APPLICATION FOR LAND USE CONSISTENCY DETERMINATION  
San Mateo County Airport Land Use Commission  
C/CAG ALUC

Project Name: Crestmoor

Address: 300 Piedmont Avenue

**Subject:** *Land Use Consistency Determination for 300 Piedmont Avenue, City of San Bruno*

FIGURE 1  
Overlay Map  
Airport Land Use Compatibility Plan  
San Francisco International Airport

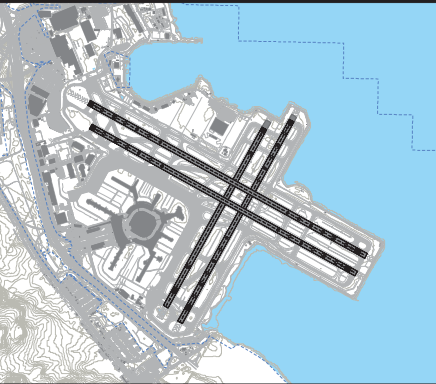
As described in Exhibit IV-17 of the SFO ALUCP (see attachment), the critical aeronautical surfaces at the Proposed Project location are at an elevation of approximately 860 feet above mean sea level (AMSL) as defined from the origin of the North American Vertical Datum of 1988 (NAVD88). The elevation of the Proposed Project site is approximately 433 feet AMSL. The maximum height of the single-family residences would be 27 feet above ground level (AGL), and maximum height of the light standards at the soccer field would be 80 feet AGL. Both of these heights would be below the height of the lowest critical aeronautical surfaces (427 feet AGL). Therefore, the Proposed Project would not appear to be inconsistent with the

SFO ALUCP Airport Influence Areas and Airspace Protection Policies  
Overlay of Tanforan Preliminary Project Application at 300 Piedmont Avenue
